# UNITED STATES PATENT AND TRADEMARK OFFICE

APPLICATION NO.	FILING DATE	FIRST NAMED INVENTOR	ATTORNEY DOCKET NO.	CONFIRMATION NO.
10/047,534	01/15/2002	Brian A. Urbach	TRW(M)5857	4987
26294	7590	05/21/2004	EXAMINER	
TAROLLI, SUNDHEIM, COVELL & TUMMINO L.L.P. 526 SUPERIOR AVENUE, SUITE 1111 CLEVEVLAND, OH 44114			GARCIA, ERNESTO	
			ART UNIT	PAPER NUMBER
			3679

**Office Action Summary**

## **DETAILED ACTION**

Fig. 3

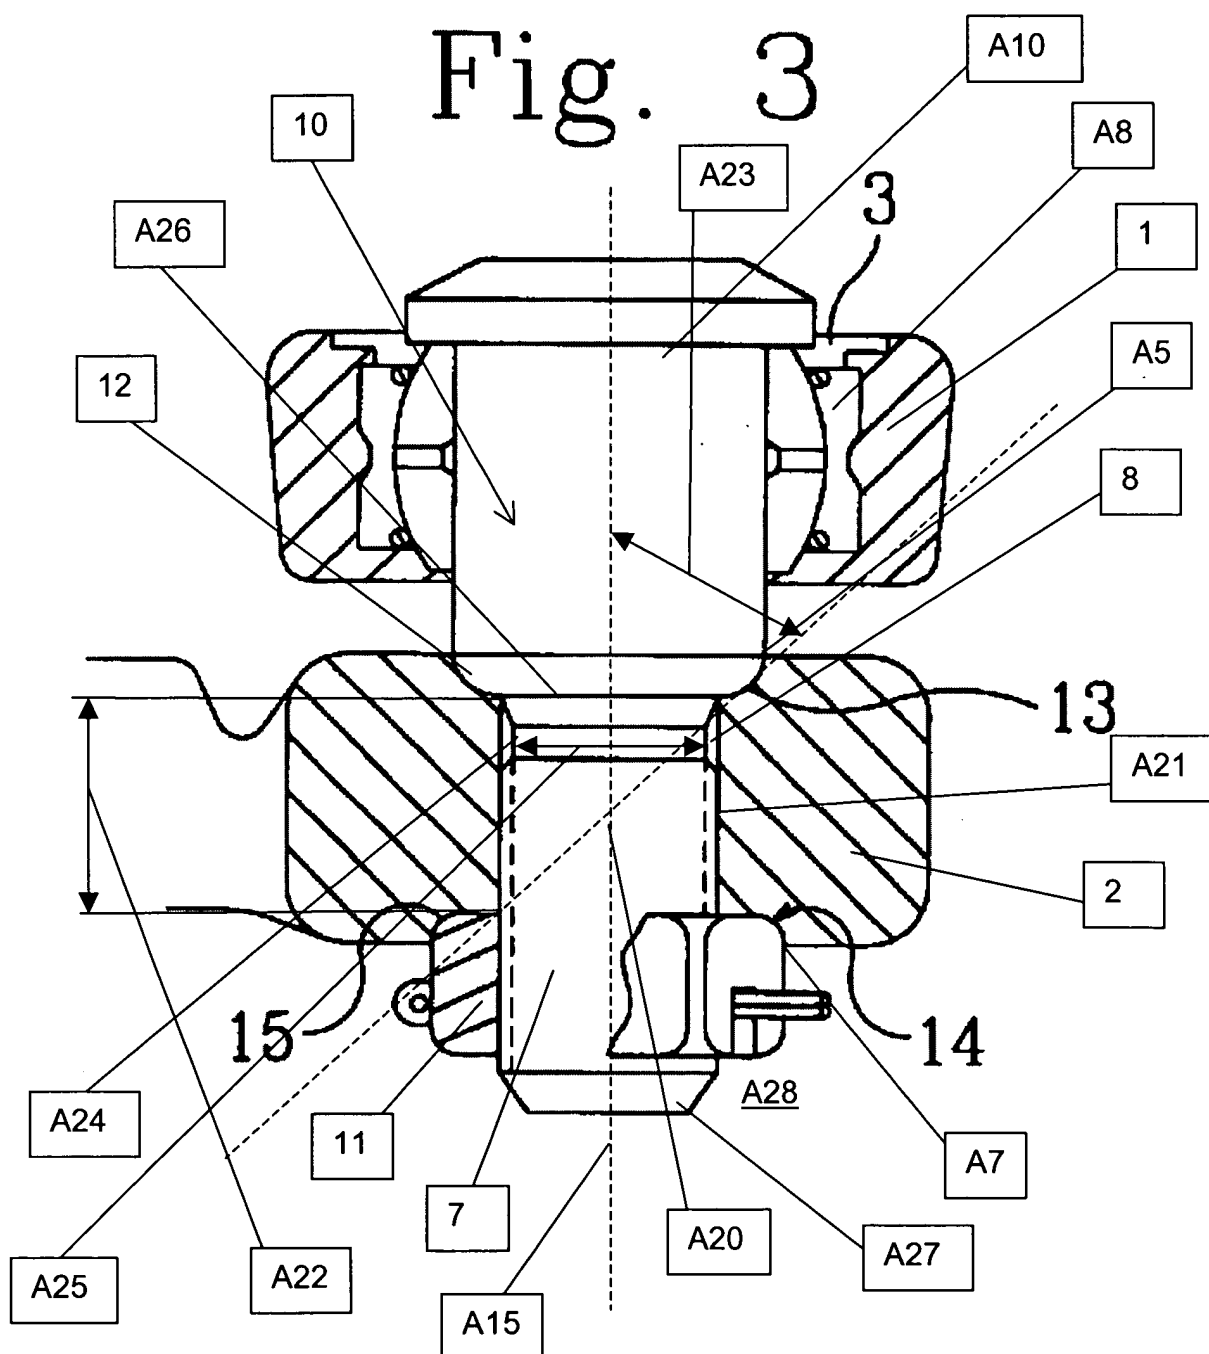
Regarding claim 1, Stroh discloses, in Figure 3, an apparatus comprising a first suspension member 1, a second suspension member 2, a socket A8, a one-piece stud 10, and a fastener 11. The second suspension member 2 has a through hole 8 with a first surface 13 and a second surface 15. The first surface 13 defines a first end A5 and the second surface 15 defines a second end A7 of the through hole 8. The first surface 13 and the second surface 15 converge toward a center A20 of the second suspension member 2. A cylindrical surface A21 is interposed between the first surface 13 and the second surface 15 and defines a central portion A22 of the through hole 8.

The socket A8 is connected with the first suspension member 1. The stud 10 has a first end portion A10 and a second end portion 7. The socket A8 supports the first end portion A10 in the socket A8. The second end portion 7 projects from the socket A8 and completely through the through hole 8. The second end portion 7 has a third surface 12 in engagement with the first surface 13. The fastener 11 is secured to the second end portion 7. The fastener 11 has a fourth surface 15 in engagement with

the second surface **15** of the second suspension member **2**. The second end portion **7** extends completely through the fastener **11**.

The socket **A8** and the stud **10** support the first suspension member **1**. The fastener **11** causes the first surface **13** and the third surface **12** to be pressed together, and the second surface **15** and the fourth surface **15** to be pressed together to secure the second suspension member **2** relative to the second end portion **7** of the stud **10**.

However, Stroh fails to disclose the first surface **13**, the second surface **15**, the third surface **12**, and the fourth surface **15** being frustoconical. Sommerer teaches, in Figure 2, a first surface **B1**, a second surface **B2**, a third surface **B3**, and a fourth surface **B4** being frustoconical. Sommerer does not explicitly explain why the surfaces are frustoconical. It appears that frustoconical surfaces are an alternative configuration for mating and aligning parts together. Applicant is urged to view Greubel et al. for support of choosing the surface to be spherical or frustoconical (col. 3, line 61 - col. 4, line 10). Therefore, as taught by Sommerer and Greubel et al., it would have been obvious to one of ordinary skill in the art at the time the invention was made to make the surfaces frustoconical to mate and align parts together.

Regarding claim 2, as modified above, the stud **10** has a longitudinal central axis **A15** on which the third surface **12** is centered. The third surface **12** of the stud **10** extends at a first angle **A23** to the central axis **A15**. The first surface **13** and the second

surface **15** of the second suspension member **2** extend at the first angle **A23** relative to the central axis **A15**.

Regarding claim 3, the fourth surface **15** on the fastener **11** extends at the first angle **A23** relative to the central axis **A15** when the fastener **11** is secured to the second end portion **7** of the stud **10**.

Regarding claim 4, the third surface **12** extends at a 45-degree angle to the central axis **A15**. Applicant is reminded that the third surface **12** extends from 0 to 90 degrees and 45 degrees is one of the angles in between.

Regarding claims 6 and 8, the second end portion **7** of the stud **10** has a cylindrical portion **A24** extending from the third surface **12** of the stud **10** in a direction away from the first end portion **A10** of the stud **10**. The cylindrical portion **A24** has a diameter **A25** smaller than a smallest diameter **A26** of the third surface **12** of the stud **10**. The cylindrical portion **A24** of the second end portion **7** of the stud **10** is spaced away from and extends parallel to the cylindrical surface **A21** of the second suspension member **2** when the cylindrical surface **A21** is in abutting engagement with the first surface **13**.

Regarding claim 10, as modified above, the first surface **13** and the cylindrical surface **A21** converge with one another in the through hole **8** the second suspension member **2**. The second surface **15** and the cylindrical surface **A21** converge with one another in the through hole **8** in the second suspension member **2**.

Regarding claim 11, as modified above, the cylindrical surface **A21** extends from the first surface **15** to the second surface **15** so that the first surface **13**, the second surface **15** and the cylindrical surface **A21** entirely form the through hole **8** in the second suspension member **2**.

Regarding claim 9, Stroh, as discussed above, discloses the second end portion 7 of the stud 10 includes a terminal end **A27**. The terminal end **A27** is located on a side **A28** of the fastener 11 opposite the first end portion **A10** when the fastener 11 is secured to the second end portion 7 of the stud 10. However, Stroh fails to disclose the terminal end **A27** having a hexagonal configuration. Pazdirek et al. teach in Figure 2 a terminal end having a hexagonal configuration (see Fig. 1 from the top view). Pazdirek et al. do not elaborate on this feature. It appears however, that the hexagonal configuration prevents the stud from being rotated in a through hole when a fastener is fastened to a threaded portion of the stud. Therefore, as taught by Pazdirek et al., it would have been obvious to one of ordinary skill in the art at the time the invention was made to make the terminal end have the hexagonal configuration to prevent the stud from slipping in the through hole when the fastener is fastened to the stud.
